**Addendum 1**  
**ITB#22-21-209686**  
**Fairbanks Yard: Drainage Rehabilitation**

Addendum number 1 has been issued for questions/ clarification.

<b>ALASKA RAILROAD CORPORATION</b> ENGINEERING SERVICES P.O. BOX 107500, ANCHORAGE, ALASKA 99510-7500		
PROJECT : <b>FAIRBANKS RAILYARD DRAINAGE REHABILITATION</b>		
TITLE: <b>PROPOSED STORM DRAIN DETAILS</b>		
DESIGNED BY: ARRC	SCALE : AS NOTED	AFE NO.: 10918
DRAWN BY: BLG	DATE : 2/1/2022	ACAD FILE:
CHECKED BY: CDR		DWG NO. <b>8</b> OF <b>9</b>
APPROVED BY: ARRC

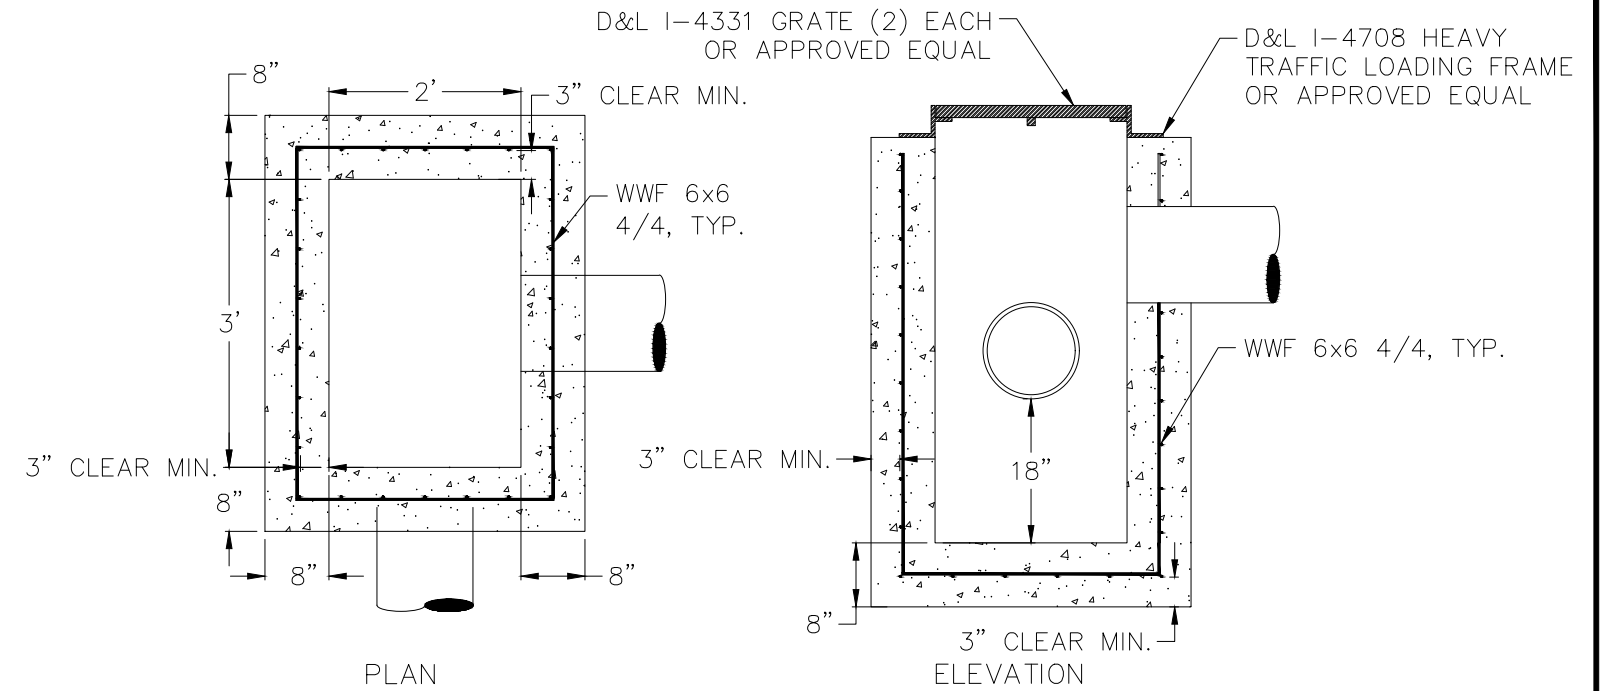
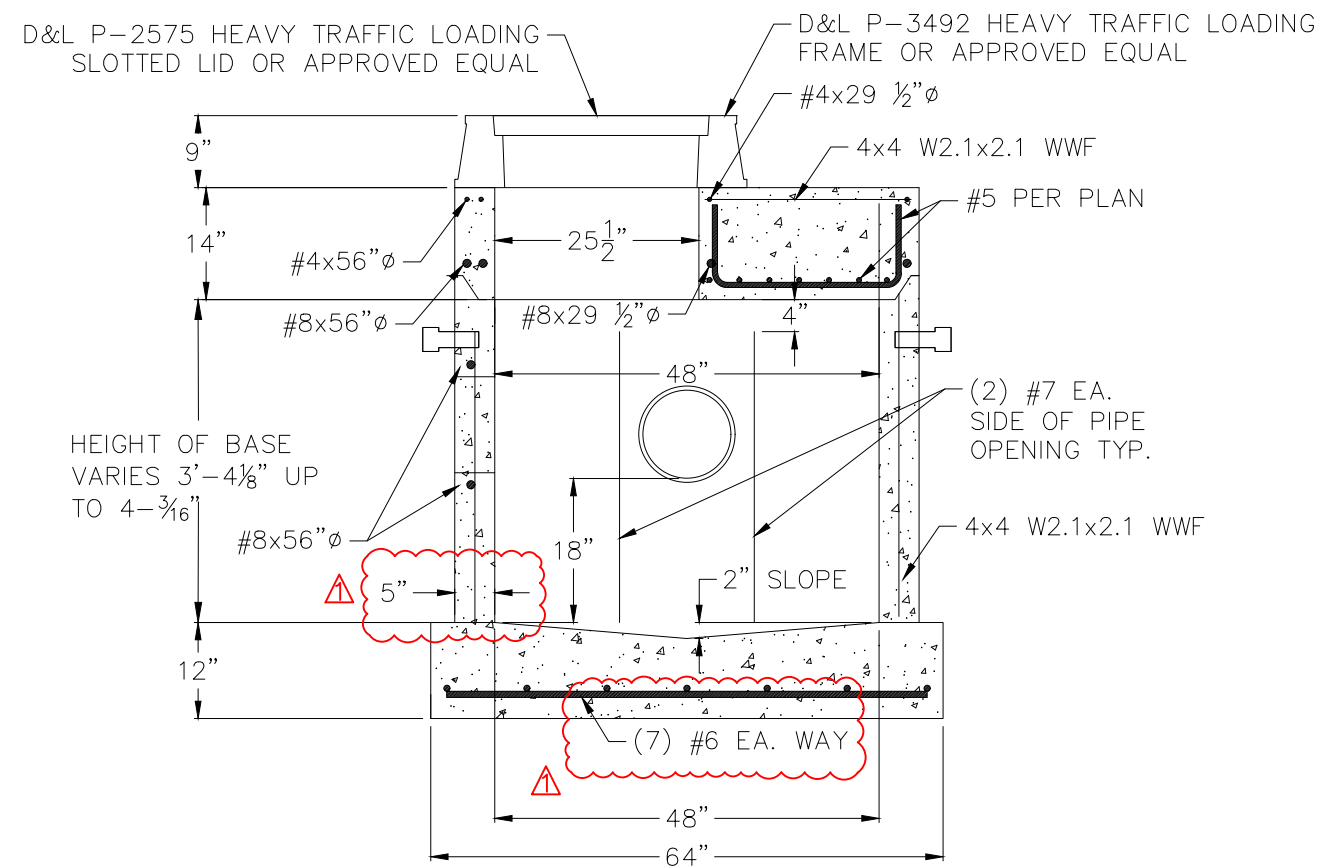
1. The 48" dia. catch basins have 6" thick walls. There are no forms that can make this size. Will this be changed?  
**Yes, the maximum wall thickness of the forms will be adjusted to 5".**
2. Could you provide clarification on the reinforcing required for the bases? 7 ea. 5' long bars won't fit in a circular base. Is that supposed to be something like 7 ea. bars equally spaced with 2" clear minimum?  
**Correct, the noted length of 5' for the #6 bars has been removed from the base. Please replace sheet 8 with the one attached herein.**
